Office Action Summary	Application No. 10/523,610	Applicant(s) YANG ET AL.	
	Examiner James A. Dudek	Art Unit 2871

DETAILED ACTION

FIG. 18

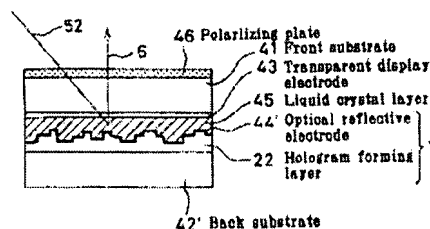
109 teaches a first panel for a liquid crystal display, the panel comprising: an insulating substrate [42]; and a light diffraction layer formed directly on an inner surface or an outer surface of the substrate and having a slit pattern or a diffraction lattice for diffracting [22] light passing through an liquid crystal layer [light 52, liquid crystal 45]; a common electrode formed on the light diffraction layer [44']; a second panel facing the first panel [41] and liquid crystal [45], wherein the width and interval of the slit pattern of the light diffraction layer have at least two different values in each pixel area [see figure 18, some of the widths are uniform and some are not, thus both uniform and non-uniform are taught]; wherein width and interval of the slit pattern of the light diffraction layer are equal to or less than seven microns [column 30, line 5, the slit space is 7 microns] and wherein first panel of any one of claims 1 through 7 comprise a second panel facing the first panel [12]; and a liquid crystal layer interposed between the first panel and the second panel.

Per claim 13, in some embodiment the light passes through the layer 22 and layer 22 is formed from a resin.
